Request for Proposal, 18MCO538

In response refer to RFP No. 18MCO538 Addendum 1 (one) with Questions and Answers

October 19, 2018

SPECIFICATION:

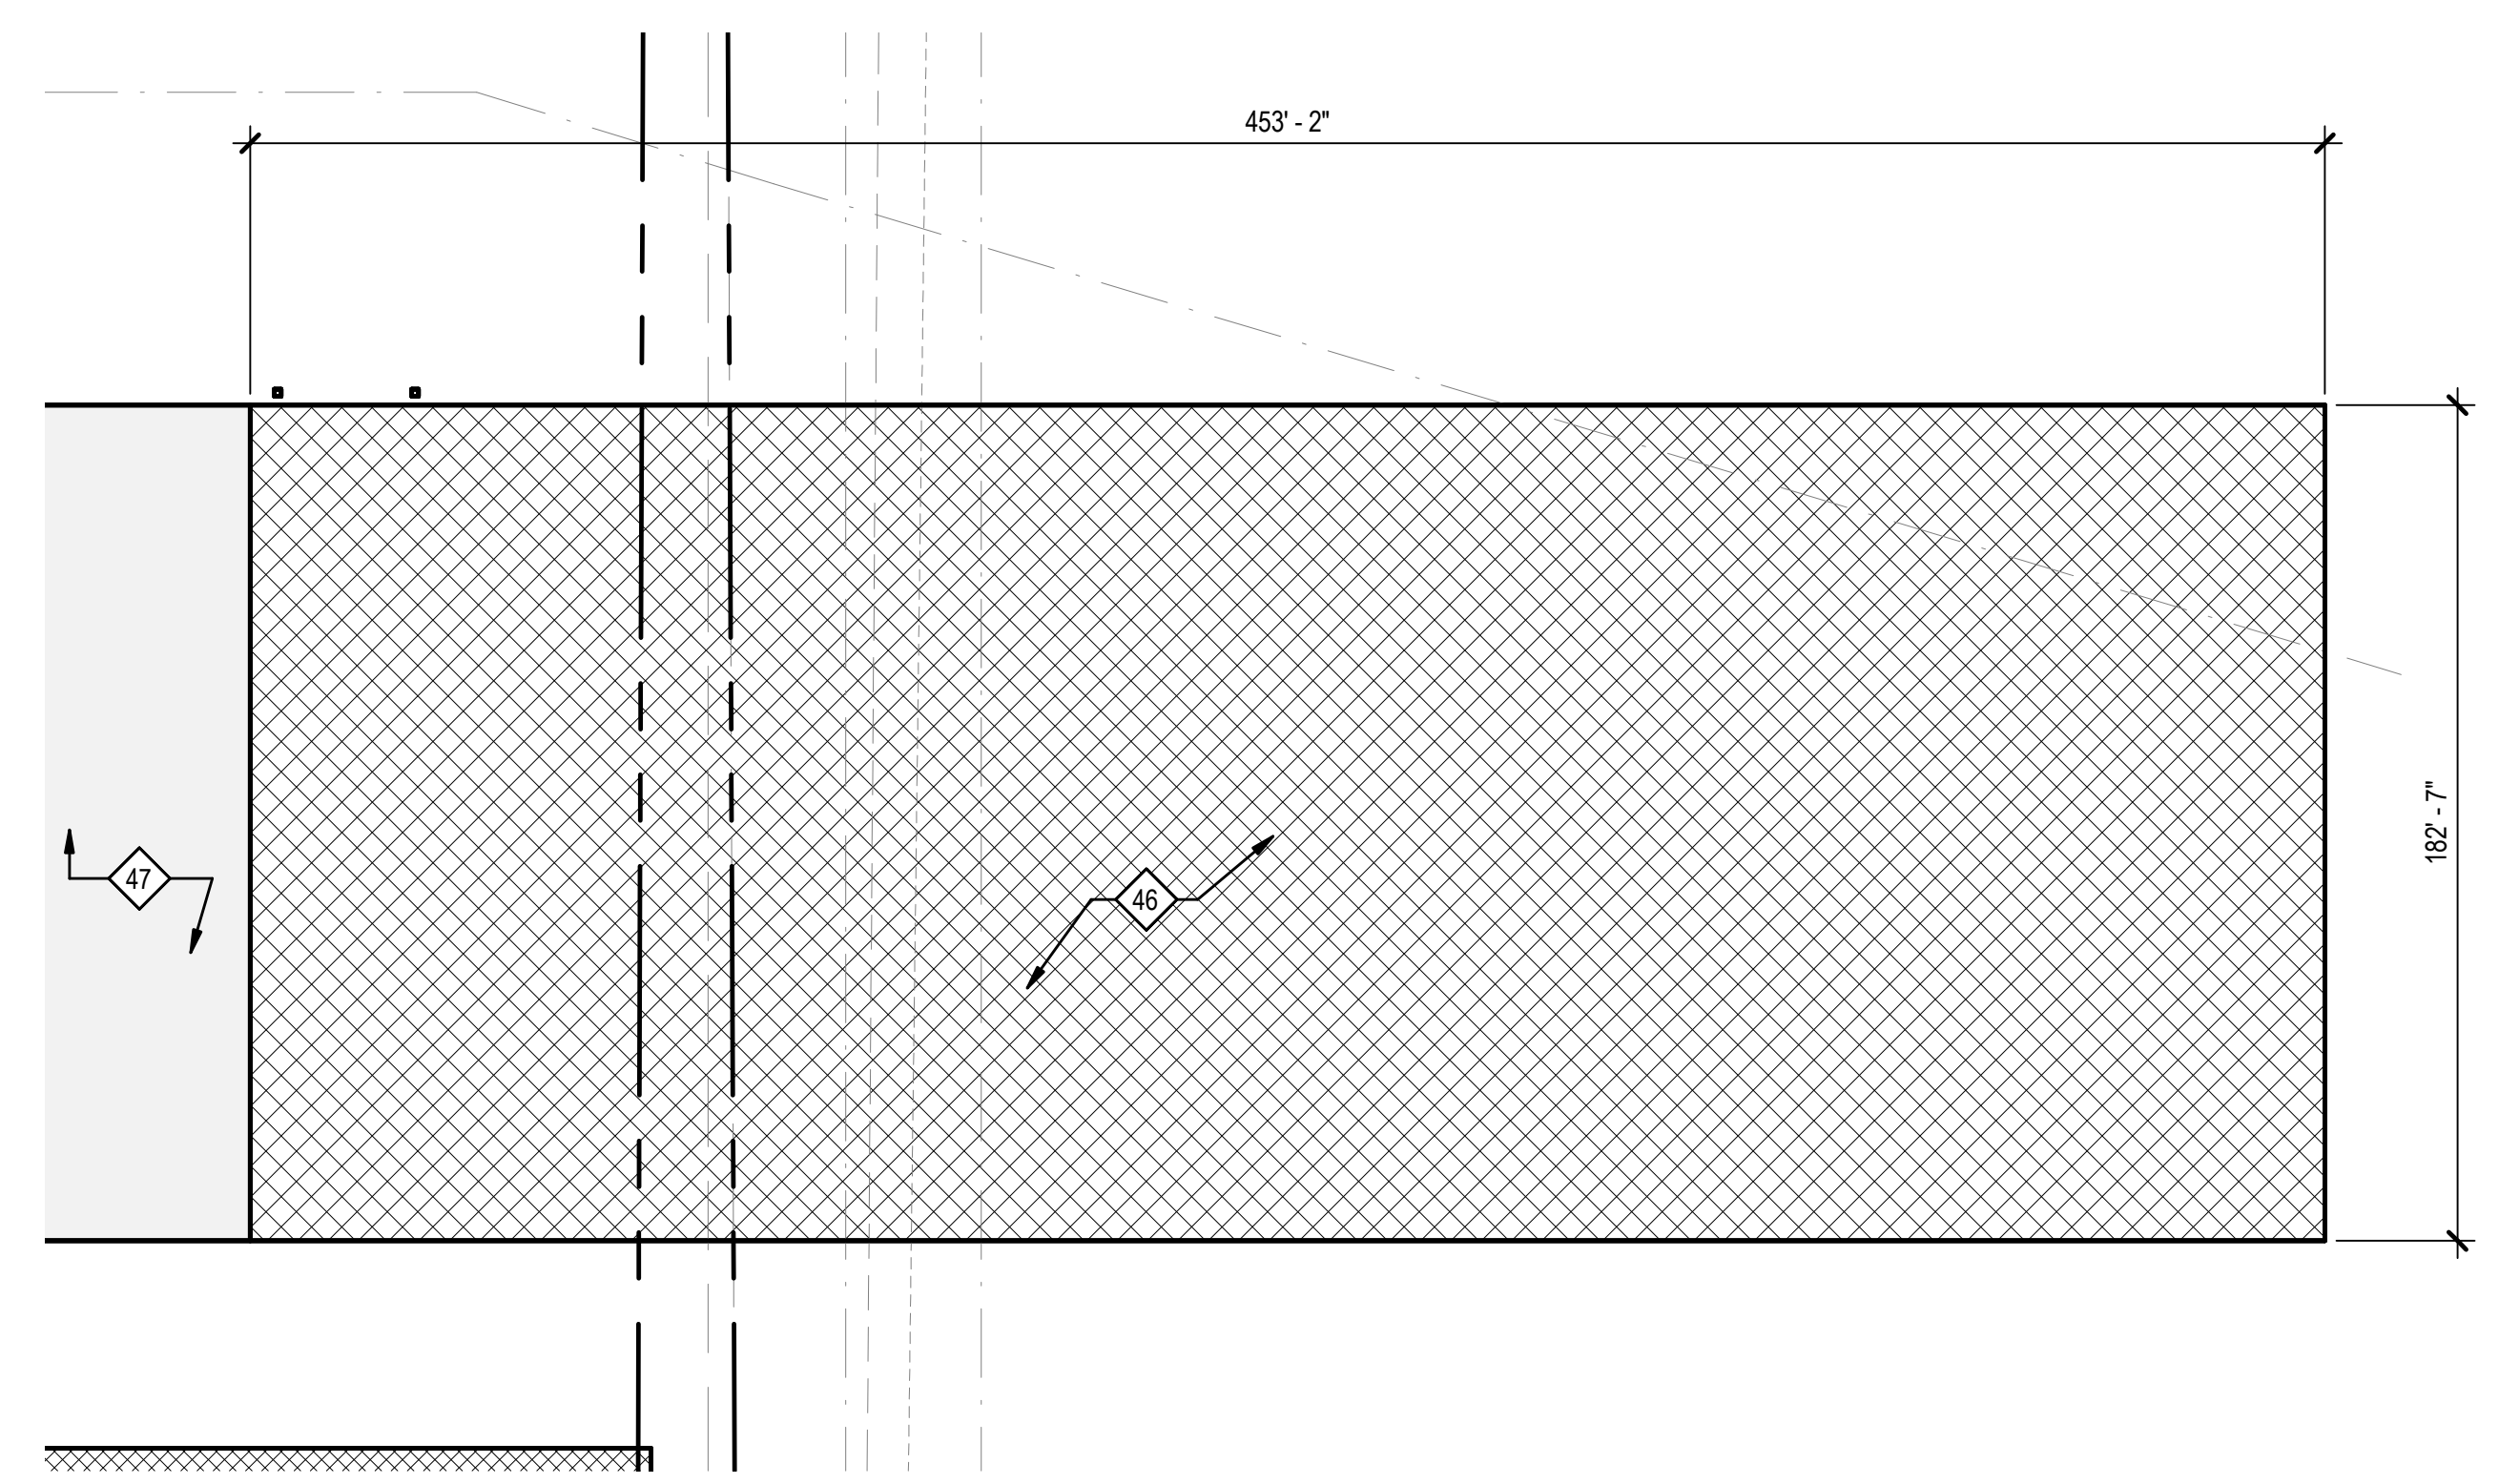
Vendor will be responsible for providing all supplies, equipment and labor to re-pave these lots with an asphalt paving as smooth as Arena Trail (the road leading into the Horseshoe Complex from S. Garfield St. This project is to include ~~removal of current pavement and~~ hauling away all debris. Vendor is responsible for all permitting and for meeting City of Midland codes regarding paving of parking lots. Vendor will also be responsible for re-stripping the parking spaces.

SHEET:
A-101

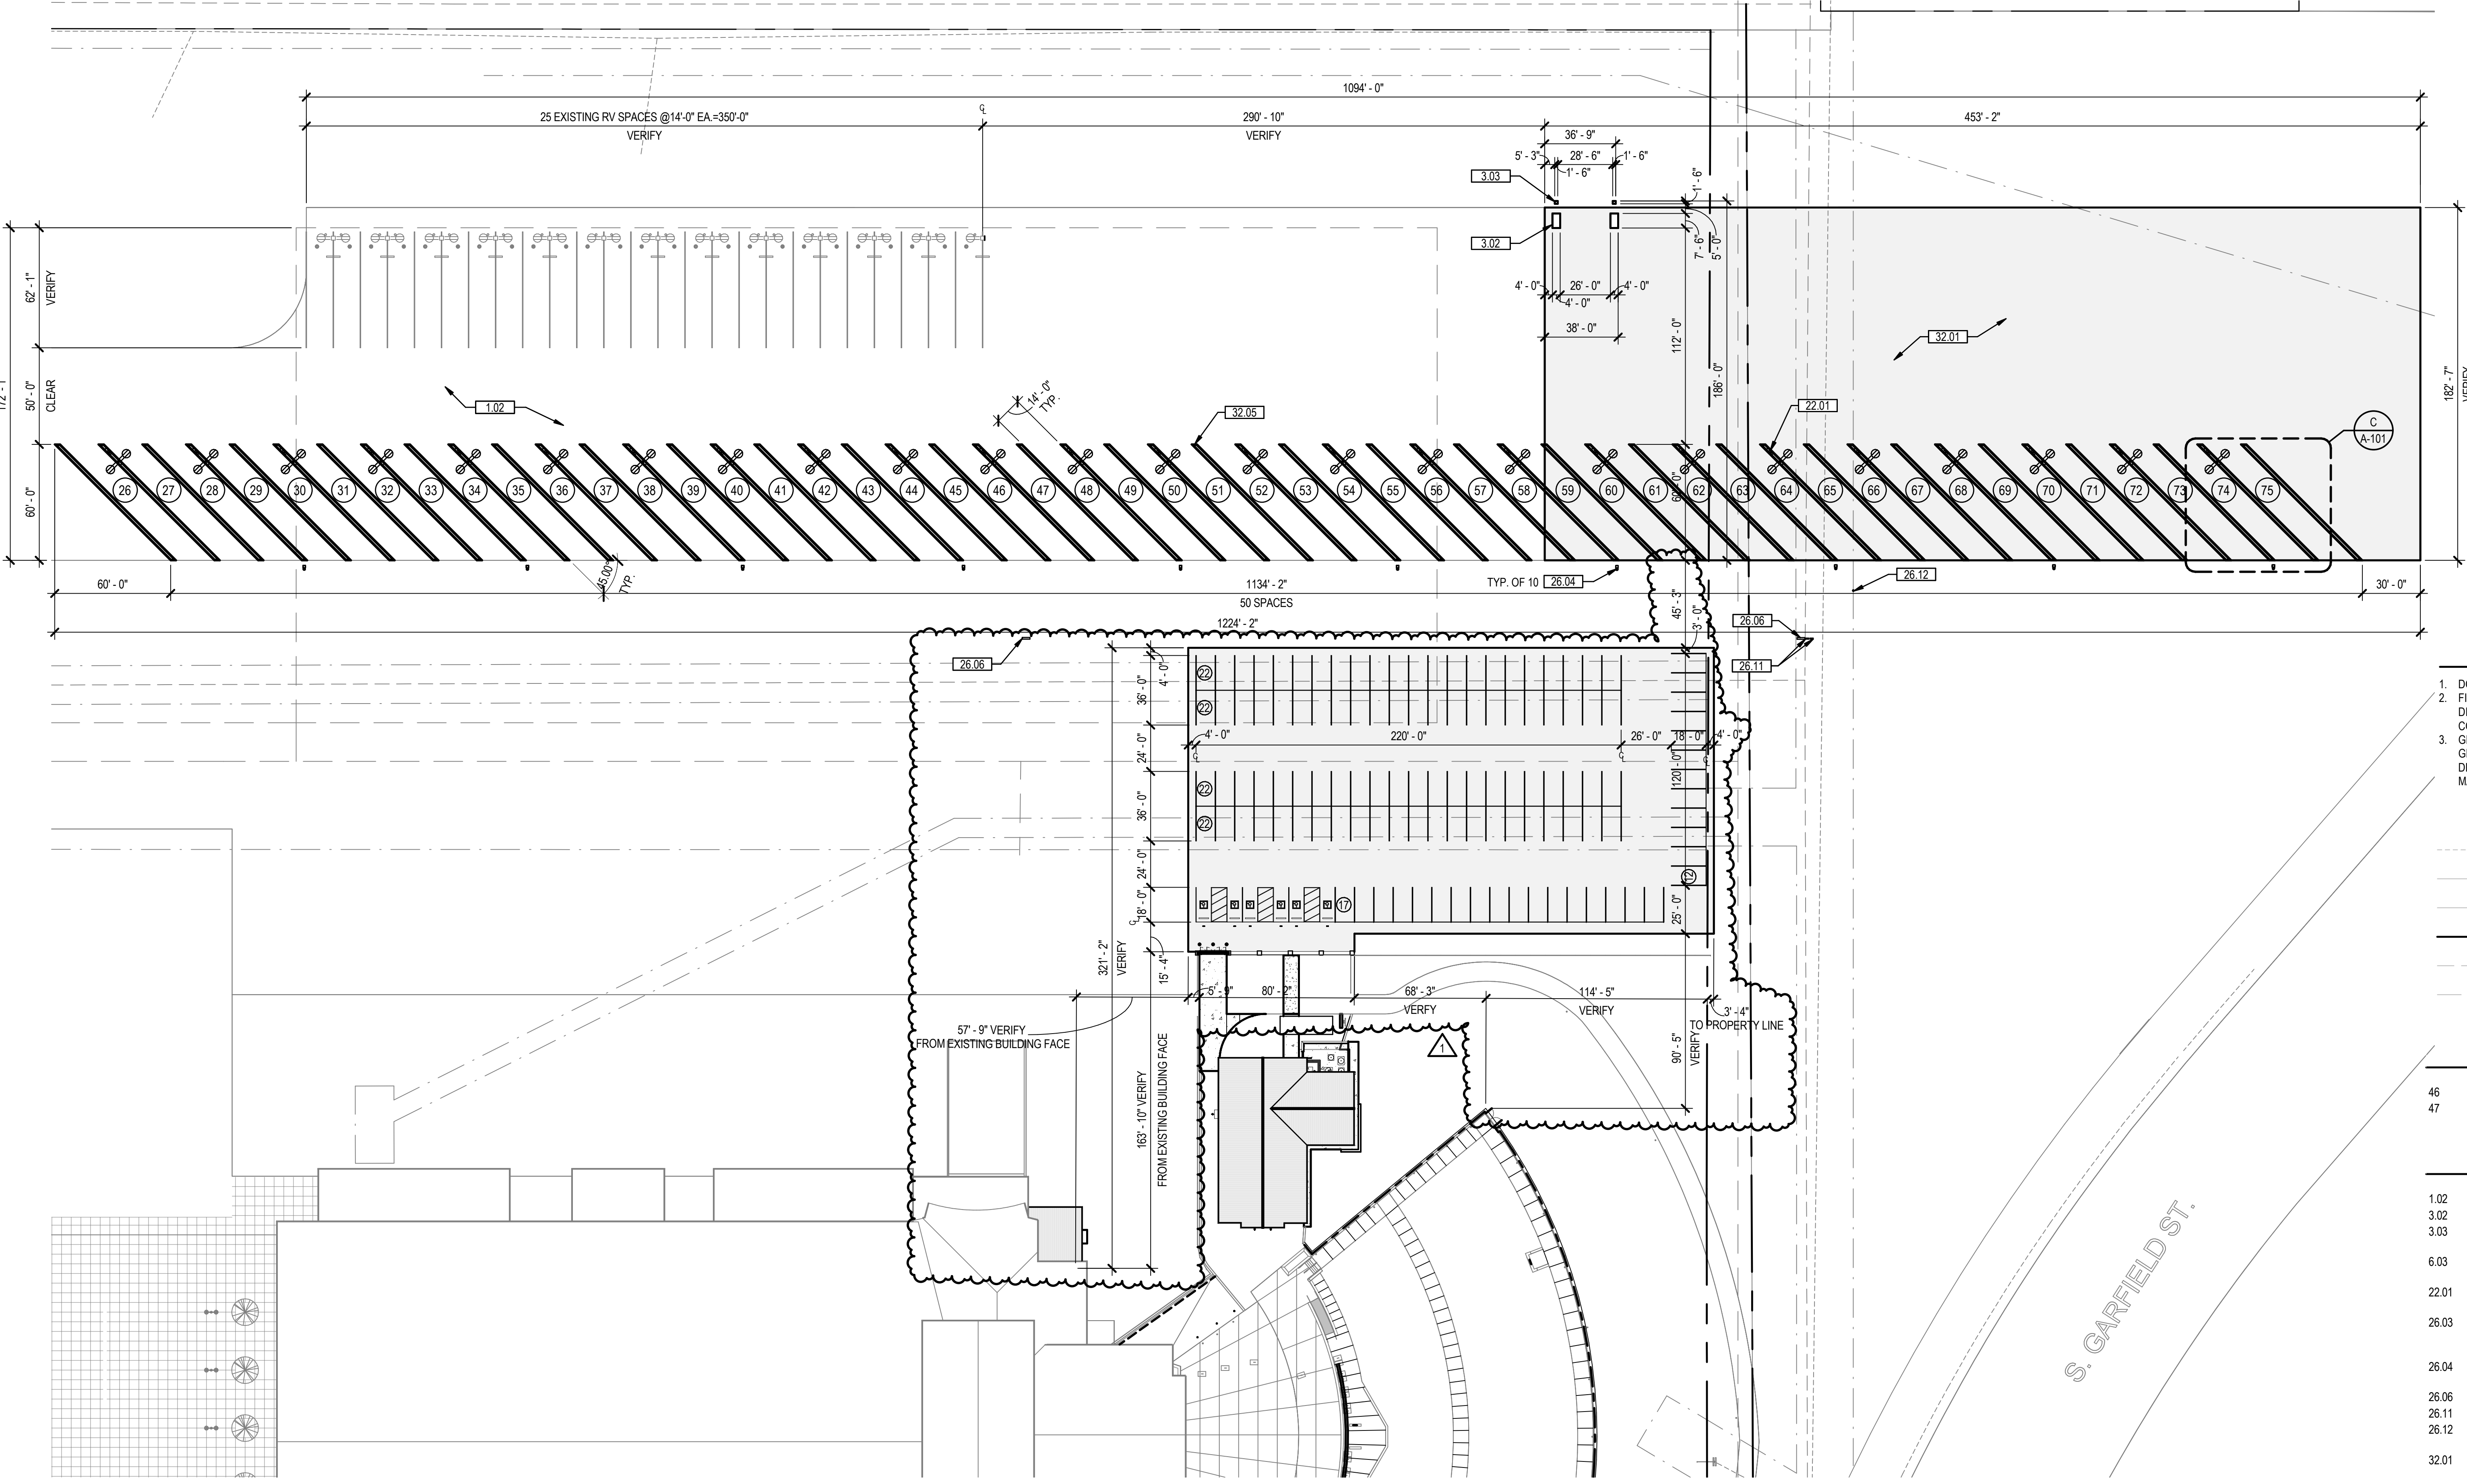
Attachment B has been added in this Addendum. Attachment B shows the dimensions and site plan for the new Hospitality Parking Area in the back of the Horseshoe.
